ADDENDUM NO. 2

FY24 Stormwater Improvements

City of Seminole

July 29, 2024

PLAN & PROFILE
(GROVE TERRACE)

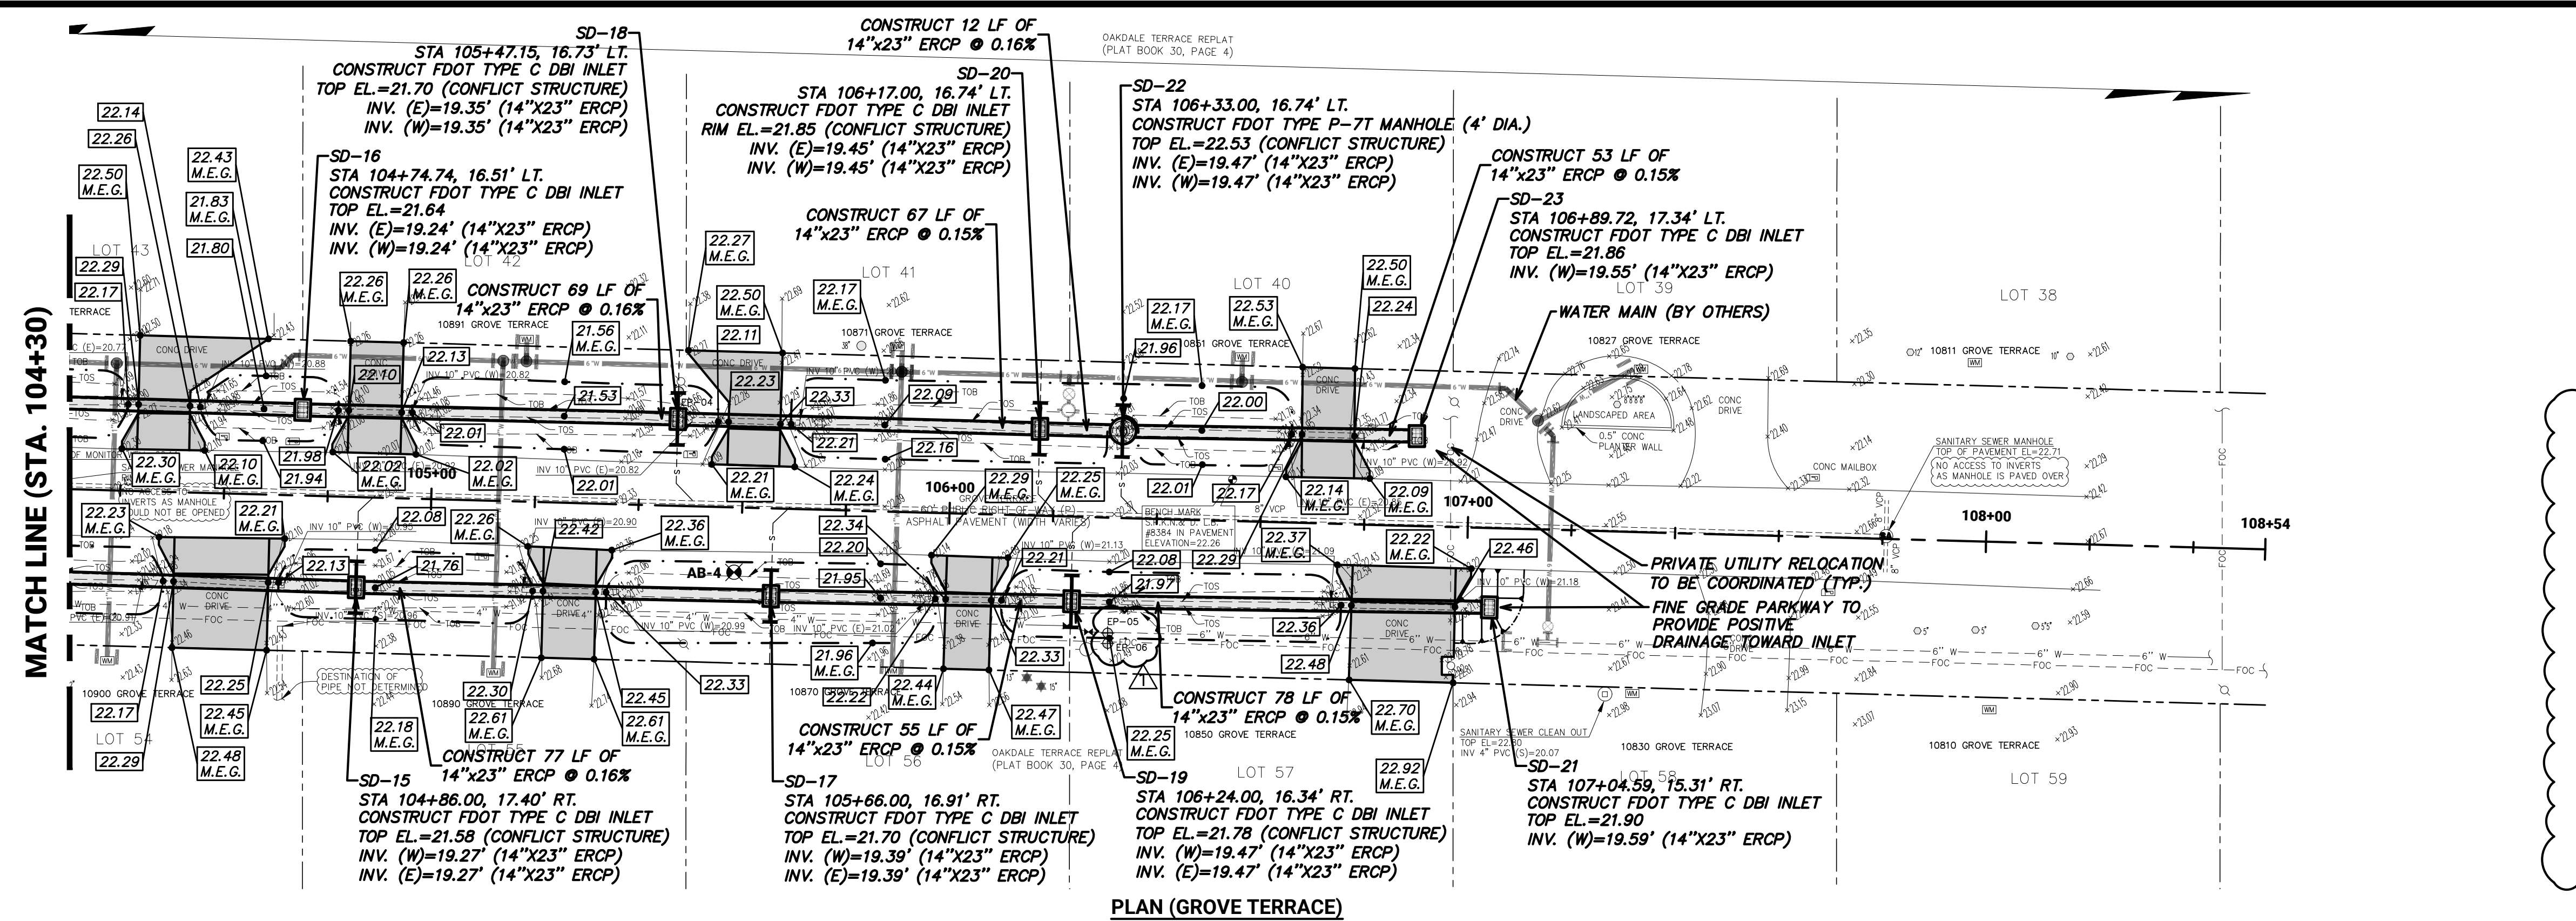
D. Sheet C7, Plan & Profile (Grove Terrace)

- a. Added notation that the Contractor shall verify the location of the existing sanitary laterals prior to the fabrication of stormwater structures.
- b. Added notation to clarify that the Contractor has the option to cast-in-place the stormwater structures if they so choose.
- c. Added notation clarifying that the existing sanitary lateral material is clay (VCP).
- d. Added notation clarifying that the existing VCP sanitary gravity system has been lined.
- e. Added locations of additional SUE activities.

- NOTES:**
1. CONTRACTOR SHALL CONFIRM LOCATIONS OF SANITARY LATERALS PRIOR TO STRUCTURE FABRICATION. CONTRACTOR SHALL ADJUST STRUCTURE INVERTS ELEVATIONS TO MAINTAIN PIPE SLOPE. ANY DEVIANCE FROM THE LATERAL LOCATIONS DEPICTED ON PLANS SHALL BE BROUGHT TO THE ATTENTION OF THE ENGINEER.
 2. CONTRACTOR HAS THE OPTION TO CAST-IN-PLACE STORMWATER CONFLICT STRUCTURES IN LIEU OF UTILIZING PRE-CAST STRUCTURES. REFERENCE DETAILS ON SHEET C11 FOR BOTH OPTIONS.
 3. EXISTING SANITARY LATERAL MATERIAL IS CLAY (VCP).
 4. EXISTING PINELLAS COUNTY VCP SANITARY GRAVITY SYSTEM IS LINED.

4 PIPE BEDDING DETAIL
NOT TO SCALE

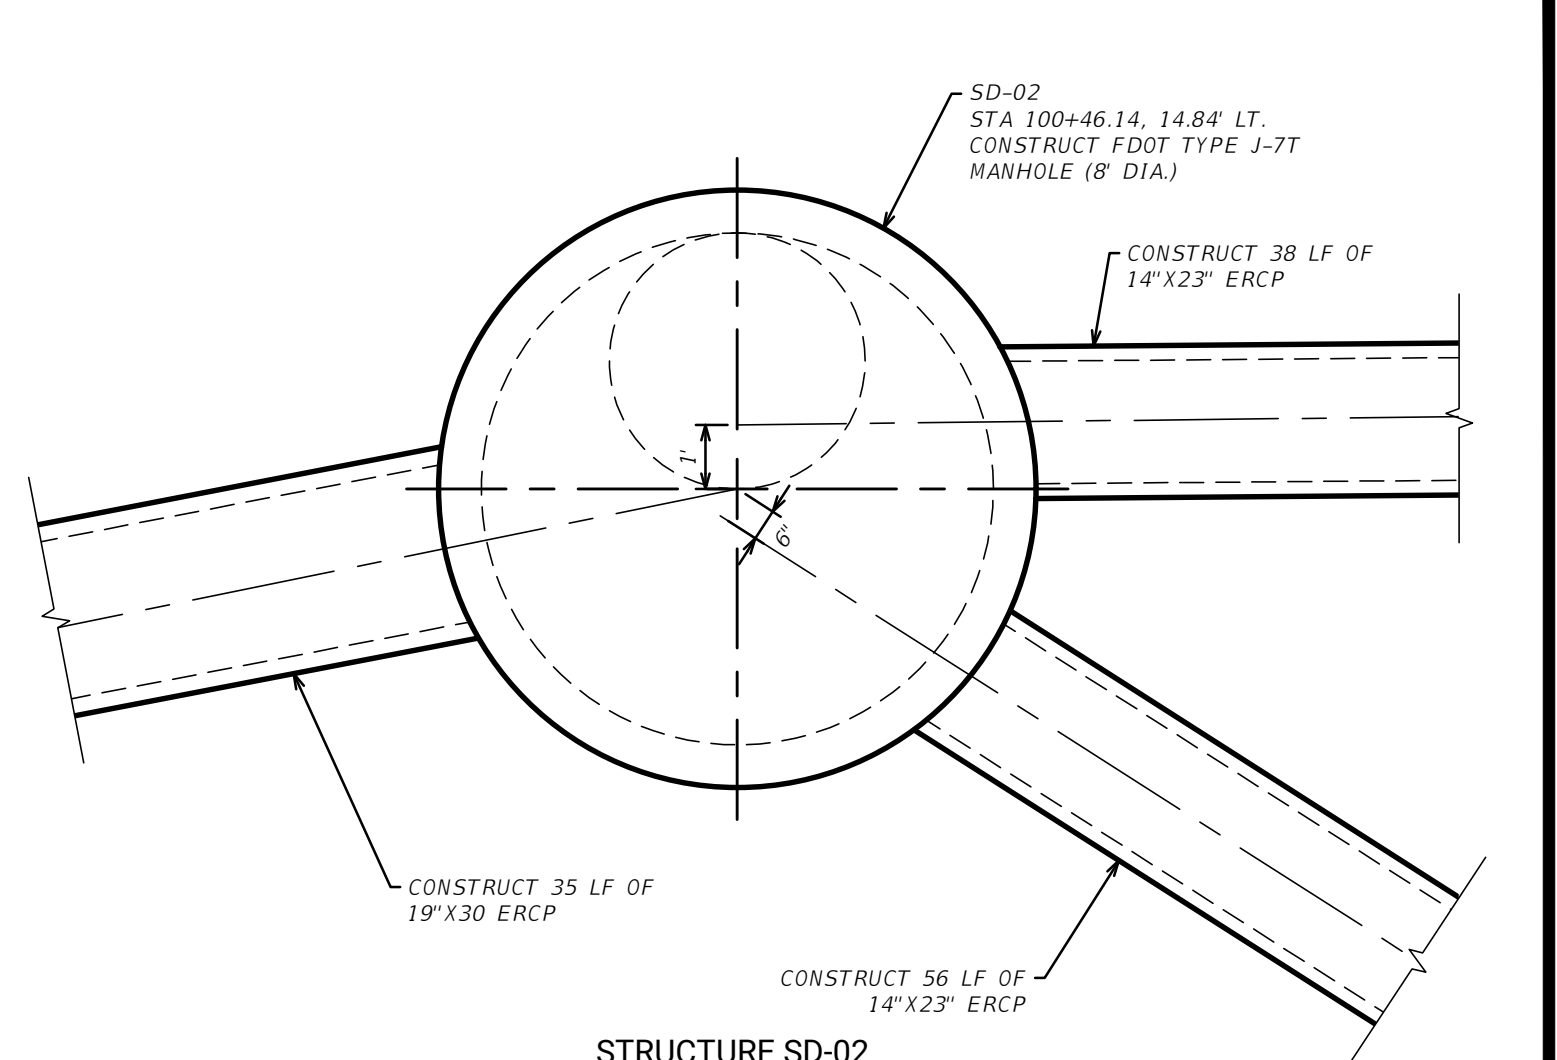
E. Sheet C11, General Details

- a. Detail 4 – Pipe Bedding Detail
 - i. Bedding material requirements have been revised.
 - ii. Added asphalt restoration requirements to the paving segment.
 - iii. Added base material and compaction requirements for the excavation restoration segment.
- b. Detail 9 – Shoulder Grading
 - i. Detail added specifying the soil compaction requirements at the shoulder and swale.

RSQ.7 Is granular bedding material directed to be used for pipe backfill?

RSQ.8 What is the required typical section for roadway to be removed and replaced?

Please reference the Pipe Bedding Detail (Detail 4) on Sheet C11 for the bedding material for pipe backfilling.

Please reference Pipe Bedding Detail (Detail 4) on Sheet C11 for the roadway restoration requirements.

- NOTES:**
- ALL BACKFILL SHALL BE PLACED IN LIFTS AND COMPACTED AS PER SPECIFICATION.
 - PAVEMENT SHALL BE 1.5" FDOT SP-9.5 (FINE) FOR TRAFFIC LEVEL C.
 - RECYCLED CONCRETE AGGREGATE SHALL BE #57 AS SPECIFIED IN FDOT SECTION 901 AND FULLY WRAPPED WITH A LAYER OF TYPE D-4 FILTER FABRIC AS SPECIFIED IN SECTION 985.

6 CAST-IN-PLACE CONFLICT STRUCTURE (OPTION 1)
N.T.S.

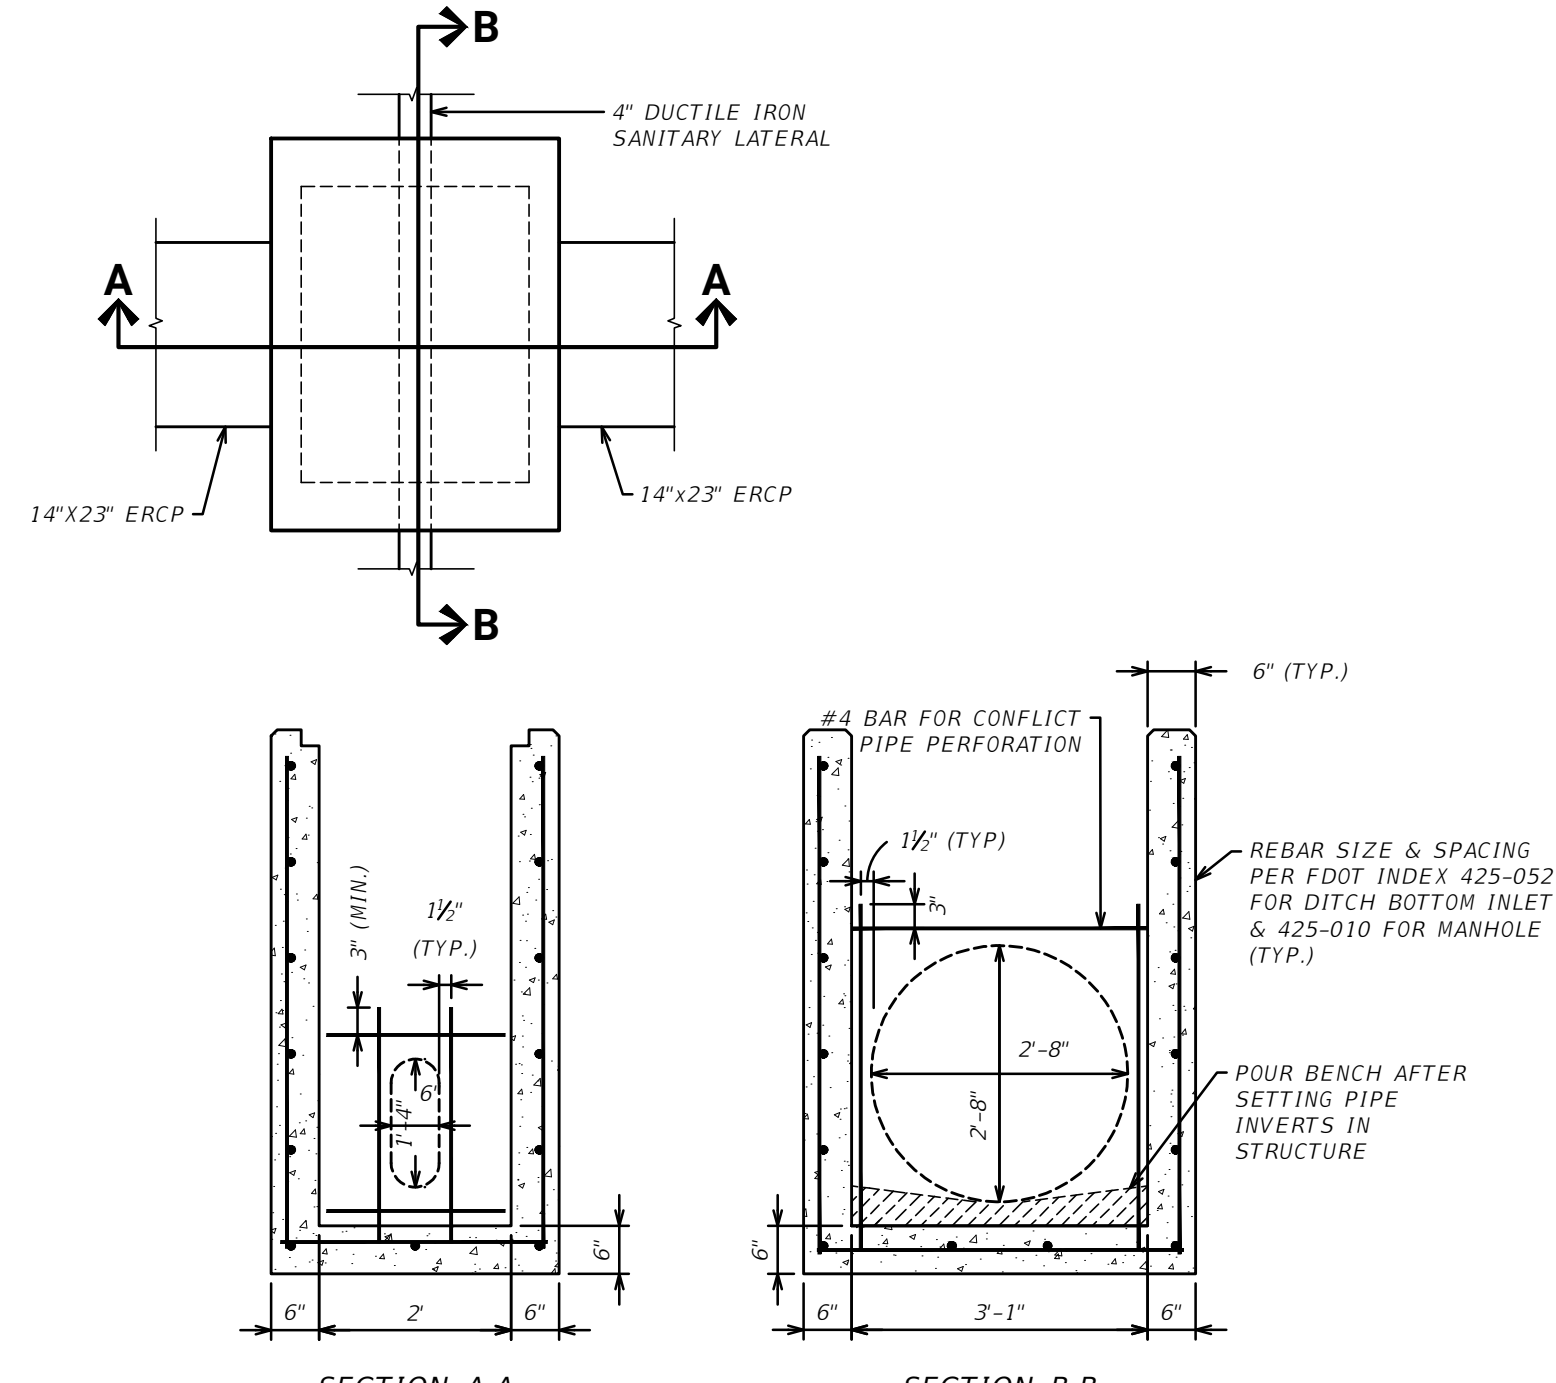
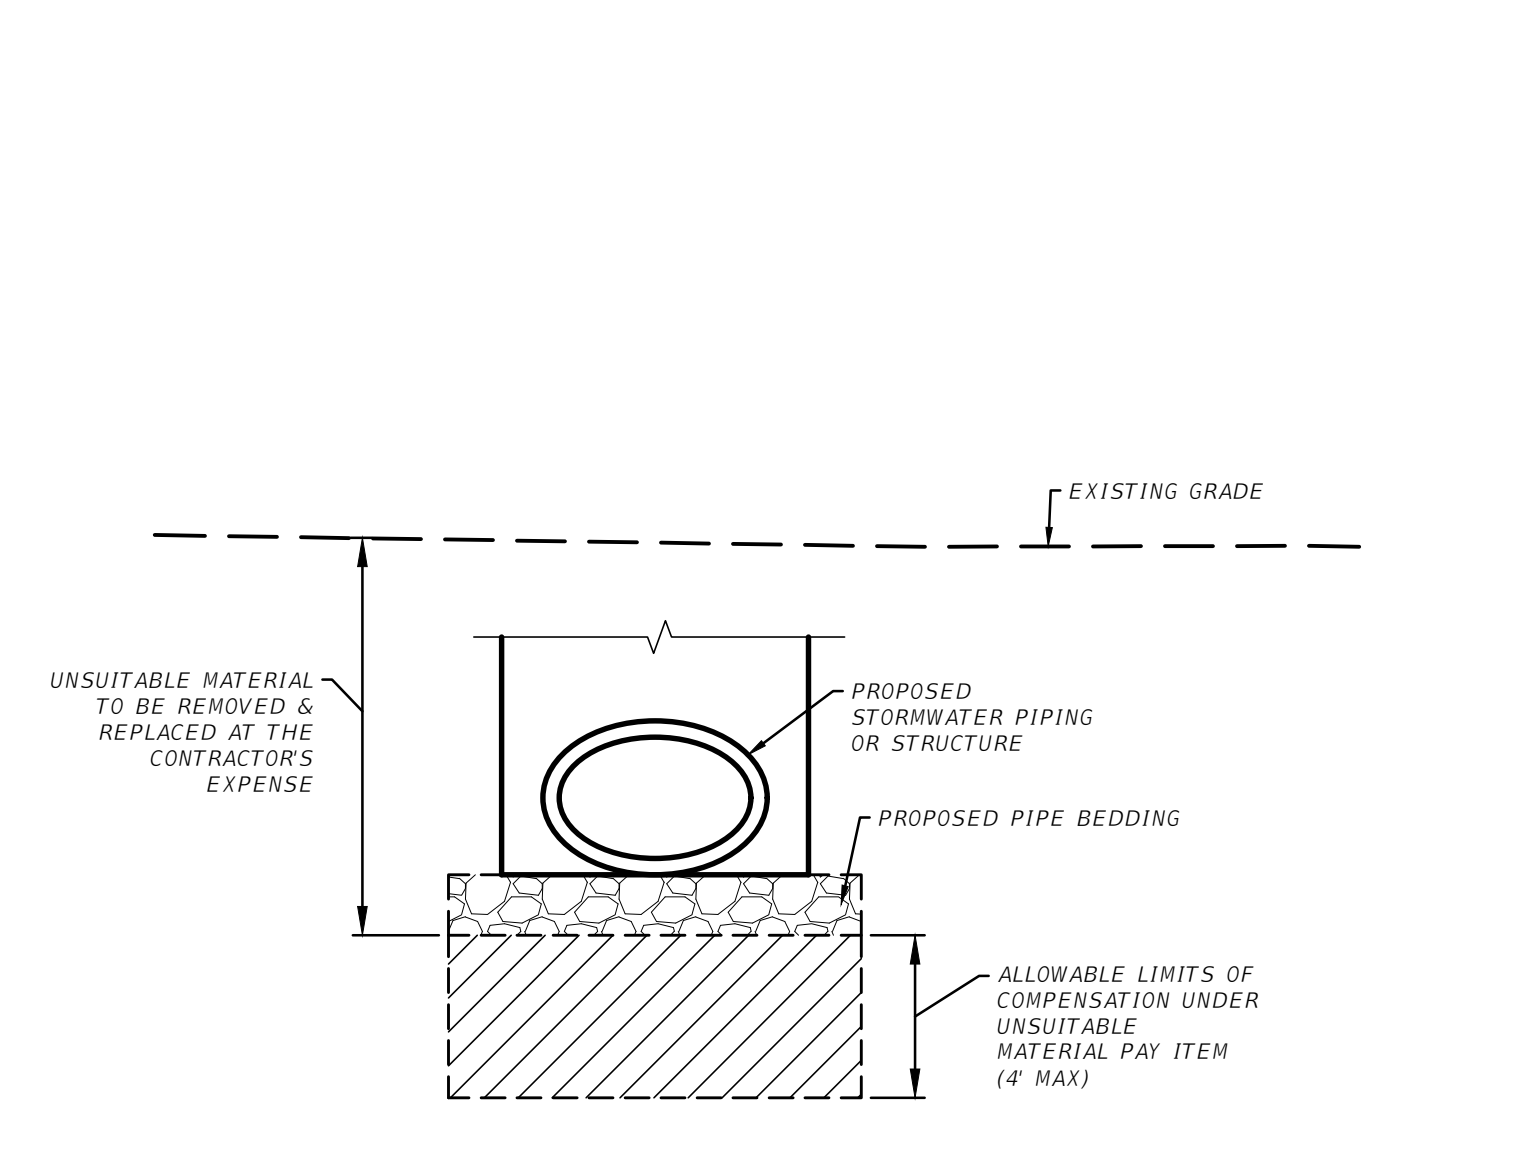
- GC.4 The Contractor may fabricate the structures in the field after confirming lateral locations in lieu of ordering precast structures. Please reference Sheet C11 for the cast-in-place or precast options.

- NOTE:**
- PIPE OPENINGS TO BE OVERSIZED VERTICALLY TO ALLOW FOR STRUCTURE PLACEMENT ADJUSTMENTS DUE TO POTENTIAL VARIANCES OF LATERAL LOCATIONS IN THE FIELD.
 - IT IS RECOMMENDED THAT THE CONTRACTOR PERFORMS EXPLORATORY WORK TO VERIFY LOCATION & DEPTH OF ALL LATERALS PRIOR TO ORDERING STRUCTURES TO LIMIT THE PIPE OPENINGS.
